UNIVERSITY WAY APARTMENTS

5247 UNIVERSITY WAY NE
SDCI Project #3021406

Recommendation Meeting
Northeast Design Review Board
July 10th, 2017

GROUND FLOOR PLAN

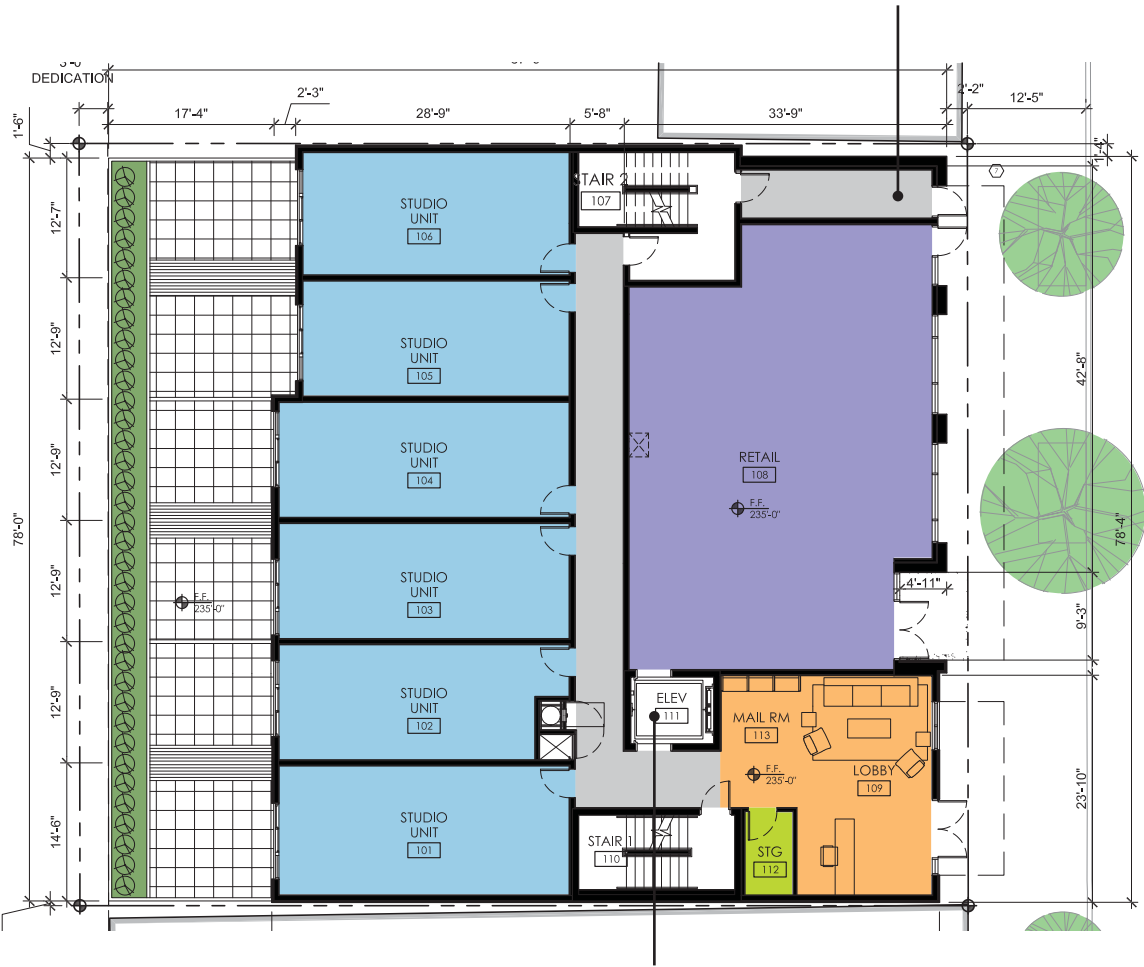
a. While rearranging the street level uses to consolidate the retail, the Board recommended studying moving the elevator south to provide a better connection to the residential lobby. (PL3-A)

c. The Board was concerned with the north exit pathway and recommended pulling the hallway forward or providing a gate to avoid a blind corner. The Board requested more detail about access and steps taken to address safety at the next meeting. (PL2-B, PL3-A-1, PL3-A-4, PL3-C-1, DC3-A-1)

Extended north exit hallway to avoid blind corner

New elevator position to provide better connection with residential lobby

RESPONSE: We have moved the elevator south right next to the lobby area in order to create a more coherent residential circulation.

RESPONSE: The north exit hallway now extends out to street to avoid the blind corner issue. Further steps have also been taken in order to address safety concerns on pathways and exits.

PARKING FLOOR PLAN

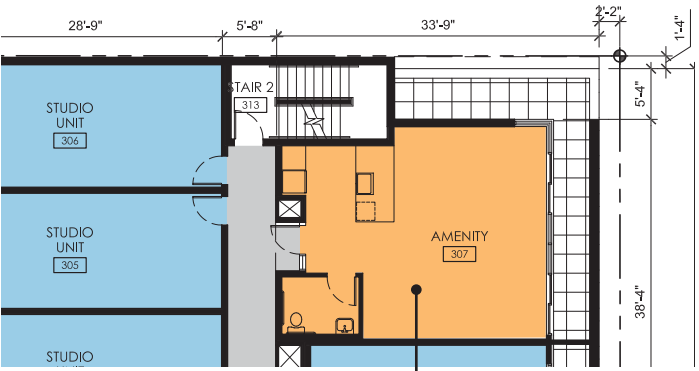
b. Recognizing that the retail trash will be carried through the elevator down to the garage, the Board agreed that the trash storage location should be better resolved to avoid the elevator used by residents. (DC1-A, DC1-C-4)

e. The Board supported the separated bike storage, as long as circulation for the bicyclist was further developed with safe and convenient access points. (PL4-A, PL4-B)

Dedicated trash room to be located next to the elevator at the parking level

More convenient bike storage location

RESPONSE: This has been further addressed with a trash chute system and a dedicated trash room at the parking level right next to the elevator.

RESPONSE: We decided to move the bike storage closer to the elevator to create a more convenient circulation for residents.

BIRDS EYE VIEW FROM ALLEY LOOKING SOUTH

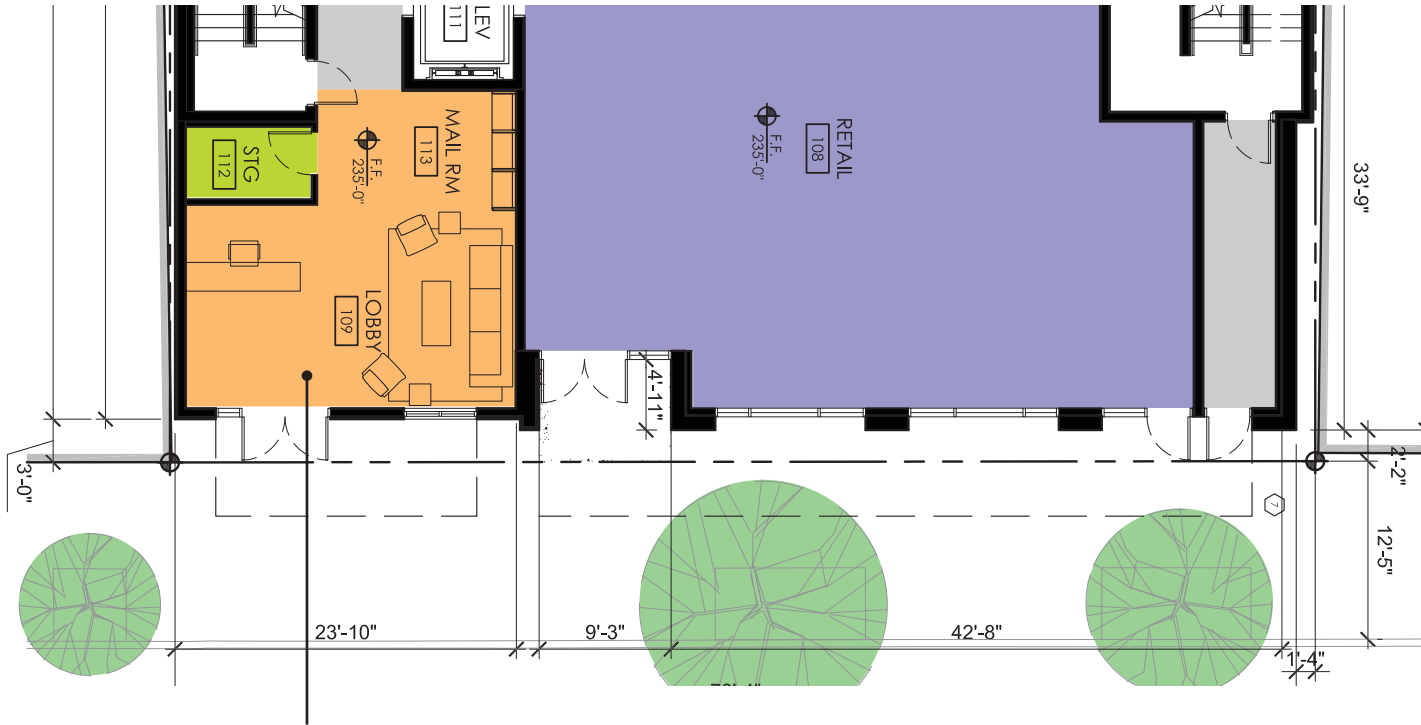
- a. The Board supported the stepped setback in response to the zone transition along the alley frontage. (CS2-D-3, CS2-D-4, CS2-D-5)
- b. The Board agreed that individual decks would minimize disrupting the privacy of residents in the adjacent properties, compared to one common deck which would likely generate noise. (CS2-D-3, CS2-D-5)
- c. For the screen walls between the individual decks, the Board supported screening composed from materials rather than a landscaped buffer which relies on maintenance. (DC4-A)

RESPONSE: We have taken into consideration the comments made by the board to develop the design further in this area. There are now individual decks to minimize disruption of privacy separated by wood screens that relate with the overall material palette and minimize maintenance.

GROUND FLOOR PLAN

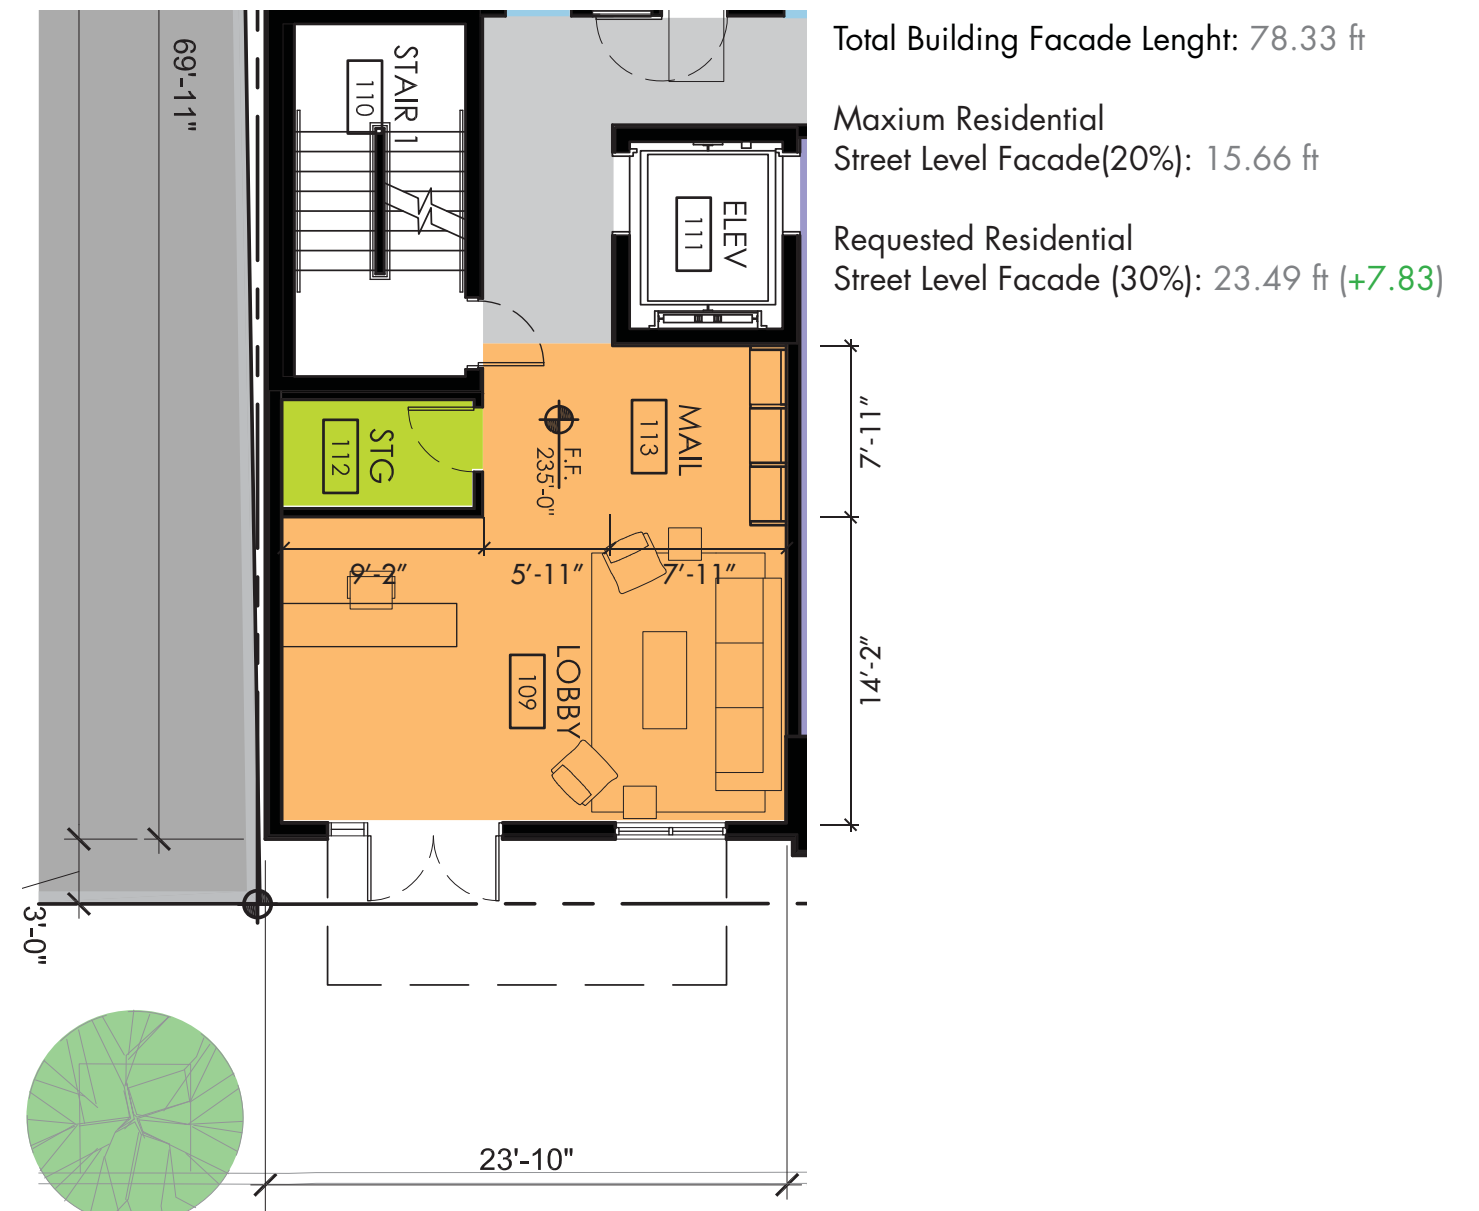
- a. The Board agreed the current rationale for the departure request to expand the amount of residential frontage from 16' to 20' does not provide a strong enough case for betting meeting the guidelines. The Board also indicated being open to a departure request as long as there is a benefit to the streetscape. Acknowledging the floor plans do not show the location of a leasing office or mailboxes, the Board requested more detailed floor plans of the lobby for the next meeting. (PL3-A, PL3-B)

DEPARTURE NUMBER	REQUIRED	REQUEST	JUSTIFICATION
1 D1	SMC 23.47A.005.C.1 Residential uses may occupy, in the aggregate, no more than 20% of street level facade facing principal pedestrian street. SMC 23.47A.005.D.1 retail/restaurant/drinking establishment uses are required along 80% of street level facade facing principal pedestrian street.	Requesting an increase of the maximum residential use percentage permitted along principal pedestrian street facade from 20% to 30%	A departure from this code section is being requested in order to allow for a functional size for the apartment lobby, considering the relatively small lot size of the development. The lot is only 80 feet wide and is a mid-block development so the maximum width for the lobby, by code, would only be 16 feet. This is very narrow considering that this area will need to have a gathering area, leasing area, mail area, storage, elevator lobby, etc. In order to make this space work more efficiently and to provide a better experience, we ask for a departure to allow the lobby to be 23'-10" wide, which is 30% of the street front facing facade (an additional 10%)

RESPONSE: The requested frontage for residential lobby is necessary in order to create a welcoming and functional residential lobby. This helps to add character to the streetscape and provide security and safety for the area.
